**PROJECT: CONSOLIDATION OF CENTRAL CITY WATER  
PROJECT #WA2015-01**

**ADDENDUM NO. 1**  
**To the Contract Provisions for**  
**CITY OF FERNDAL, WASHINGTON**

**Consolidation of Central City Water Project #WA2015-01**

The following Plan Sheets are replaced. A summary of the changes are as follow:

CONSOLIDATION OF CENTRAL  
CITY WATER ASSOCIATION  
PLAN AND PROFILE STA 0+00 - 5+00

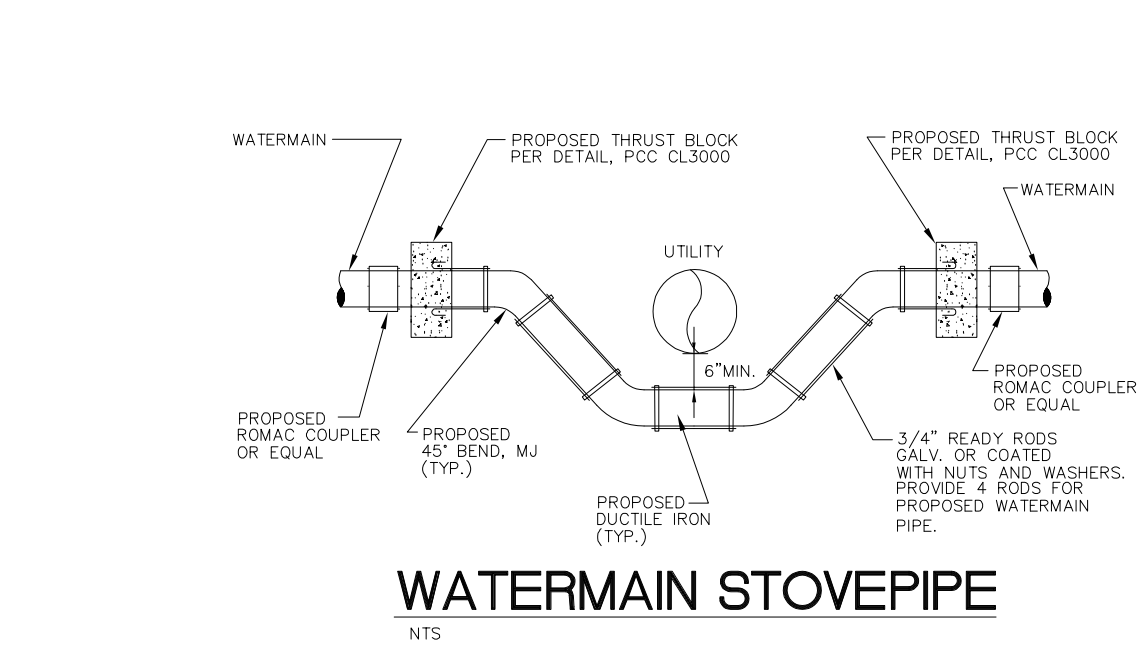
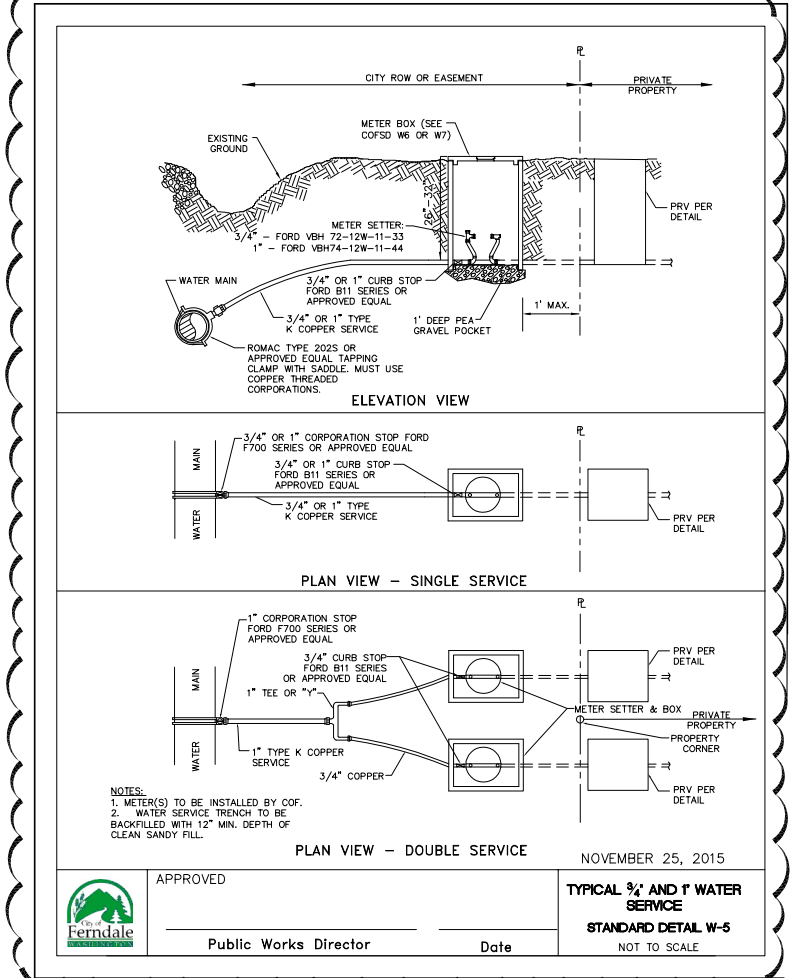
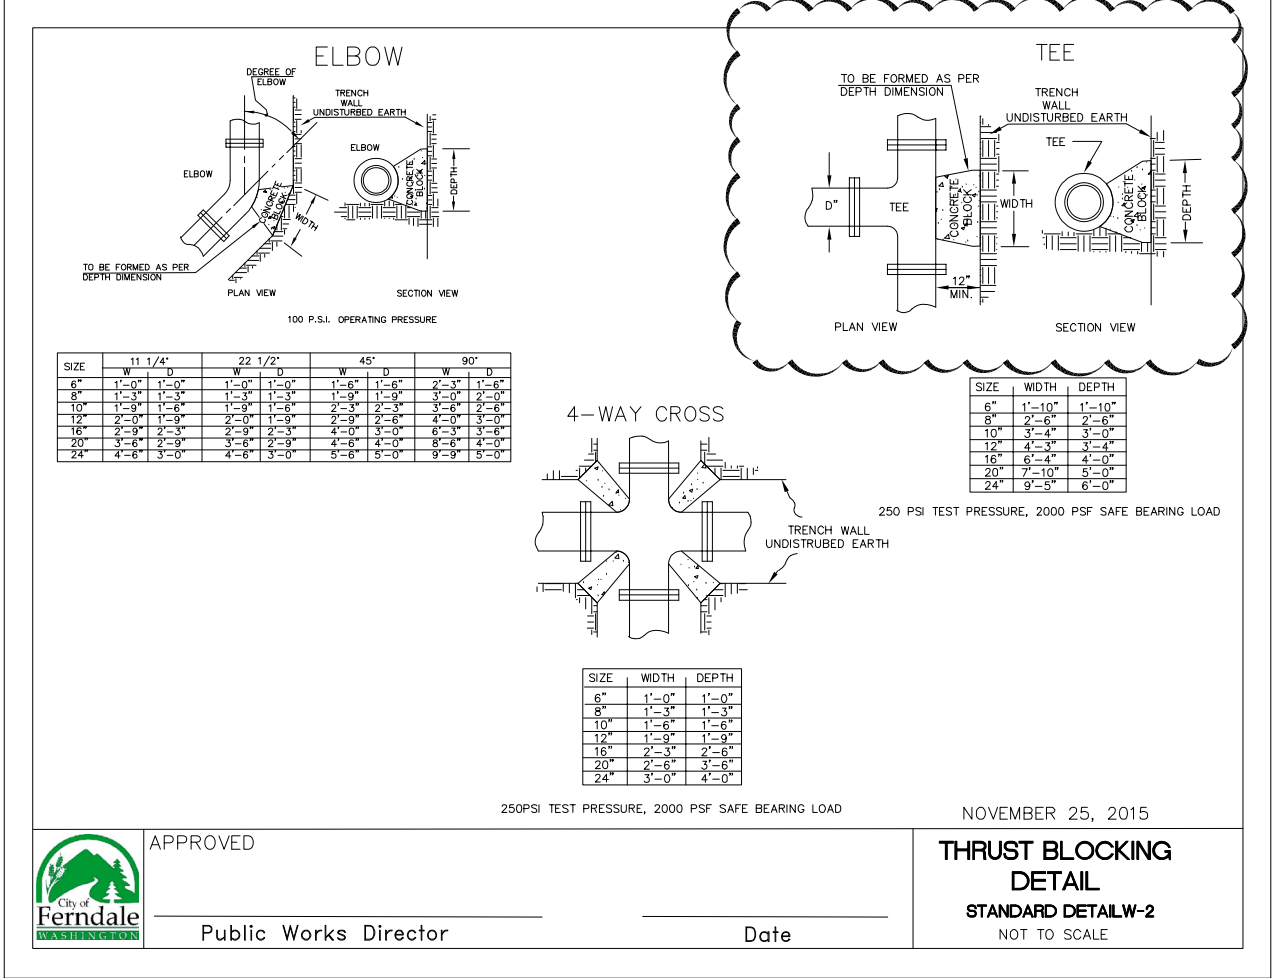
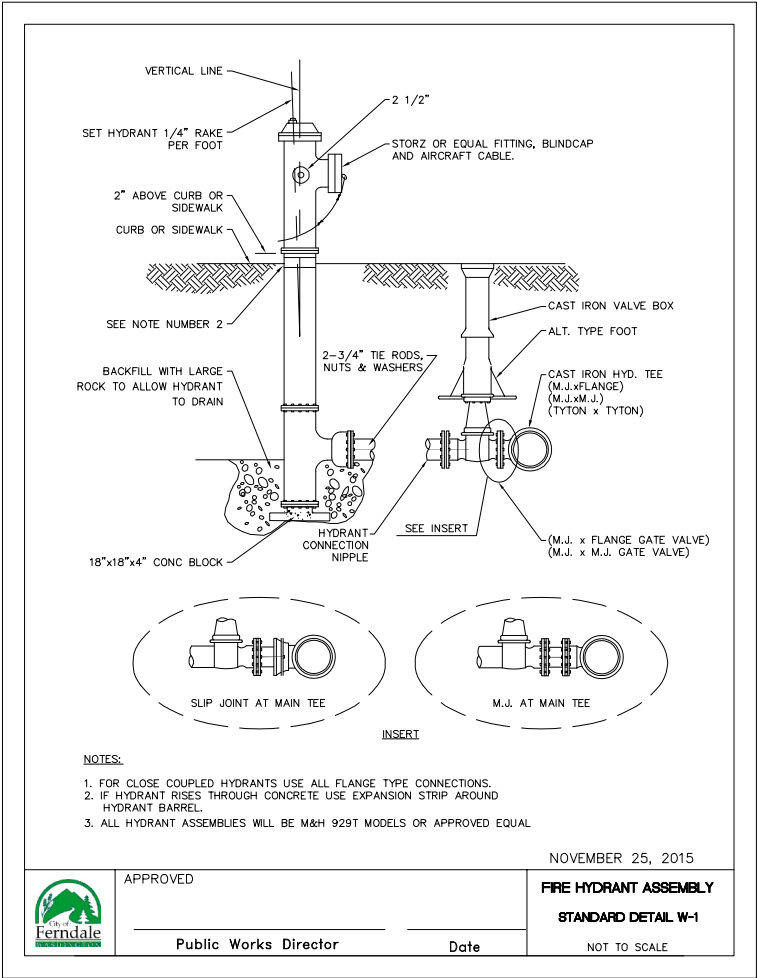
- Plan Sheet 17. The ¾" service connection at STA 0+92.06, 38.15' RT has been deleted.
- Plan Sheet 34. The THRUST BLOCKING DETAIL is corrected as the previous version showed a section of the water service connection. The TYPICAL ¾" AND 1" METER SERVICE Detail is revised to show the PRV, connection to the watermain, and Note 1 is revised.
- Plan Sheet 37. The TEMPORARY BYPASS CONNECTION AT FIELDVIEW DR Detail is revised. The existing water main and the proposed water main were added to the detail and the 8"x3" reducer was revised to a 6"x3" reducer.

1	5/25/16	ADDENDUM-1	WATER SERVICE ALREADY INSTALLED	LP
NO.	DATE		DESCRIPTION	BY

CONSOLIDATION OF CENTRAL  
CITY WATER ASSOCIATION  
DETAILS

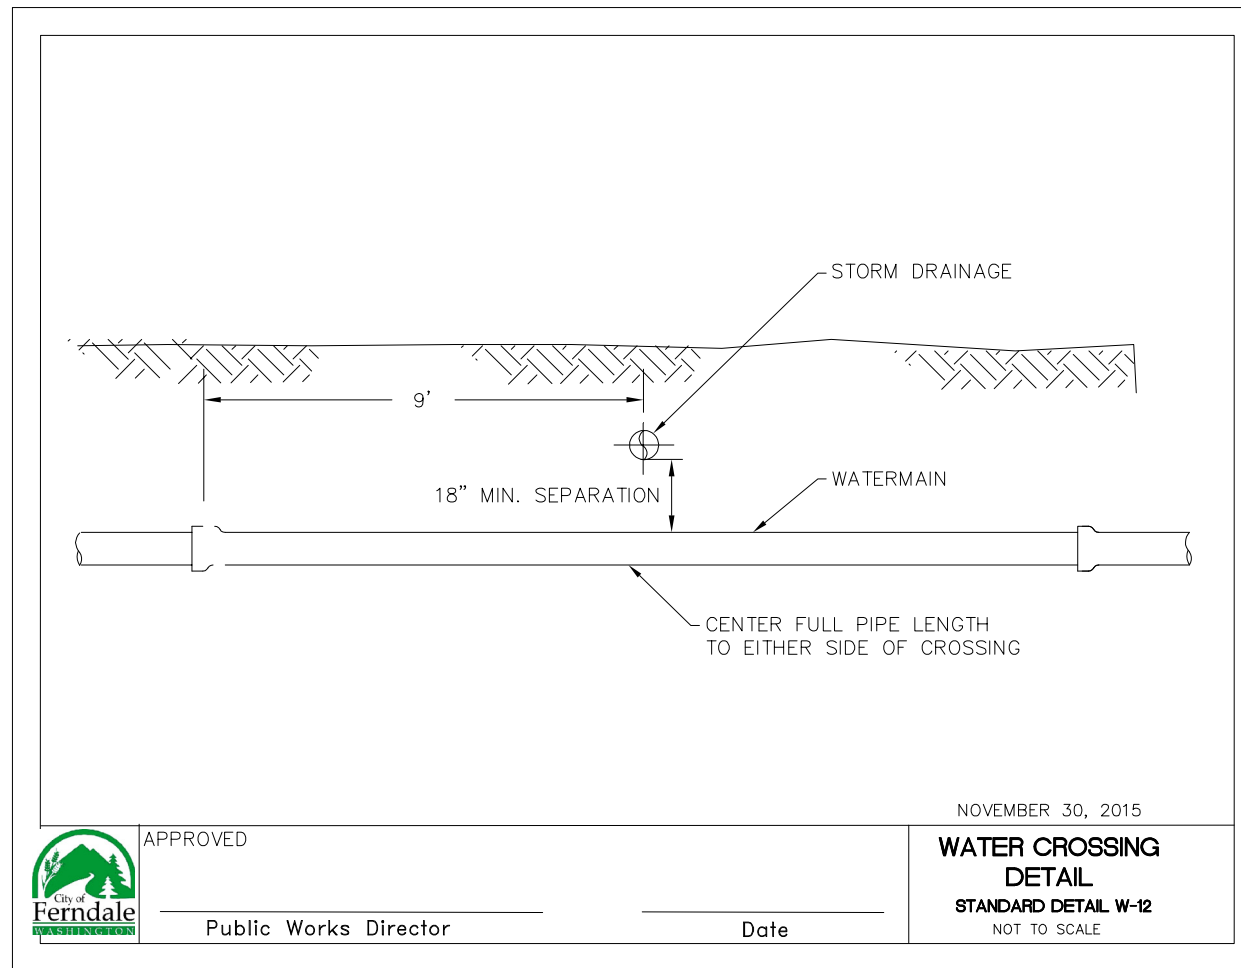
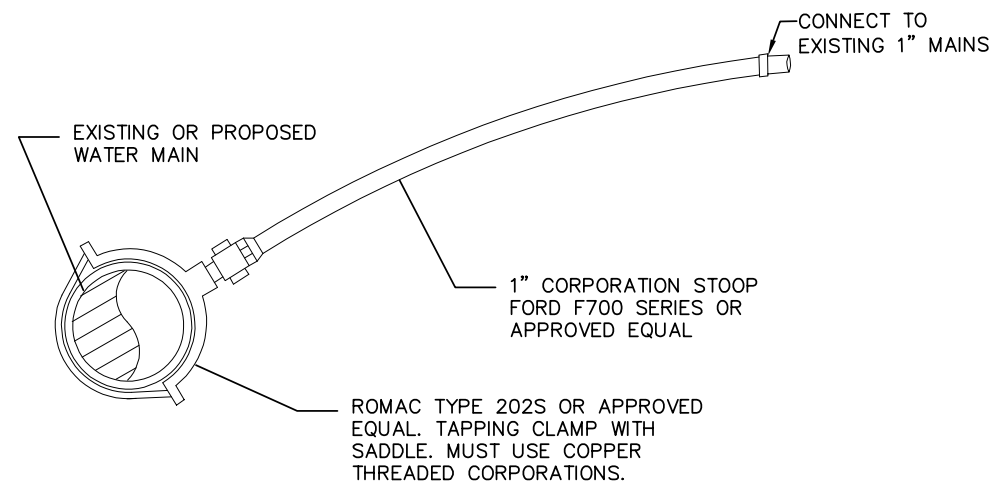
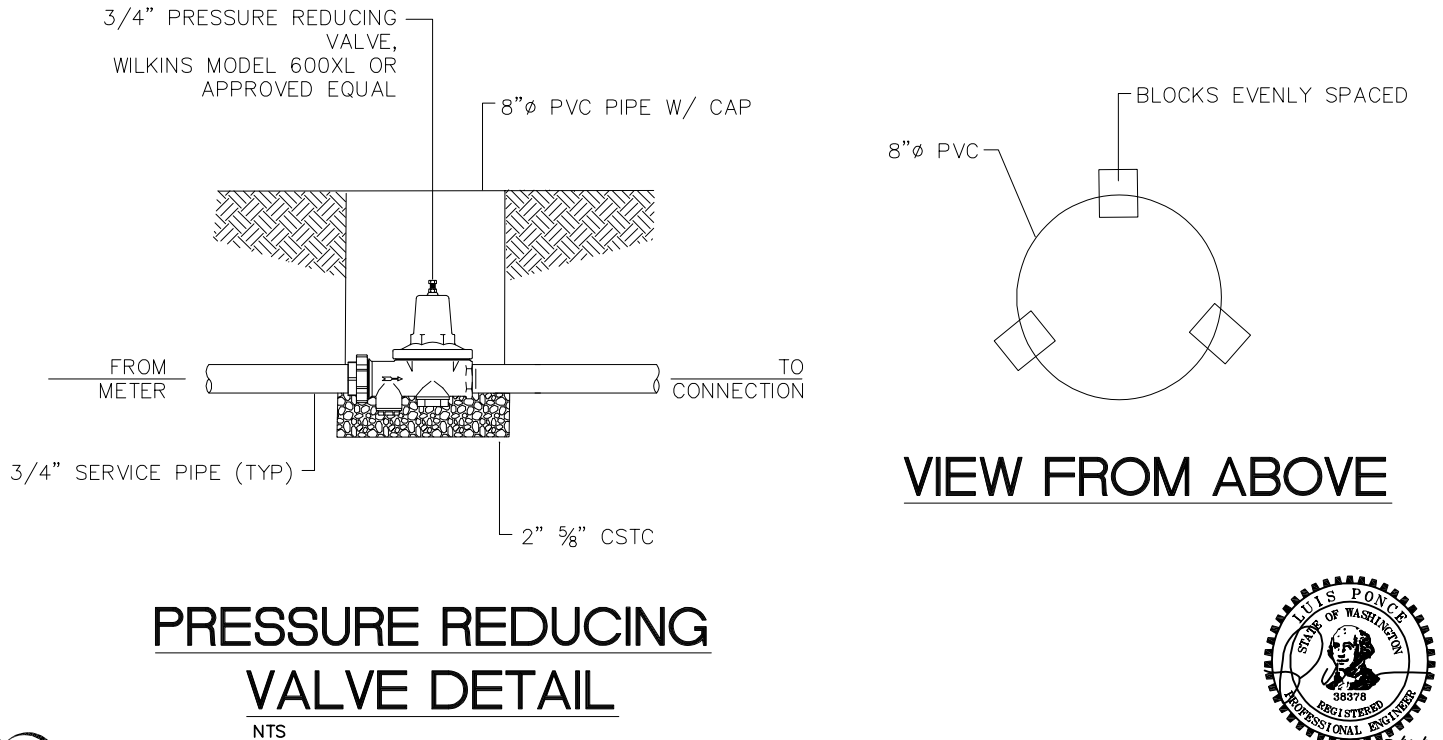
1	5/25/16	ADDENDUM-1 WATER SERVICE AND THRUST BLOCK	LP
NO.	DATE	DESCRIPTION	BY

**TEMPORARY BYPASS CONNECTION 1" AT**  
**HEIGHTS DR NORTH, HEIGHTS DR SOUTH,**  
**FIELDVIEW DR NORTH, RIDGEVIEW PL,**  
**HEATHER DR NORTH**  
NTS

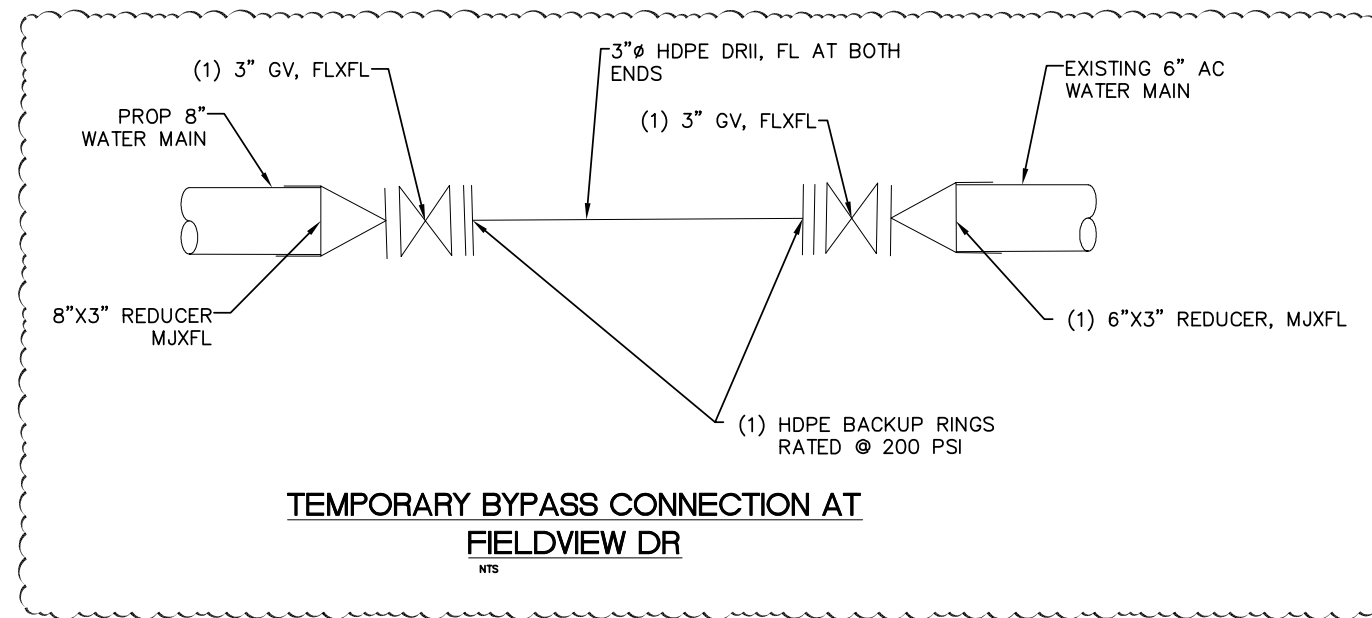
NO.	DATE	DESCRIPTION	BY
1	5/25/16	ADDENDUM-1 BYPASS CONNECTION DETAIL	LP
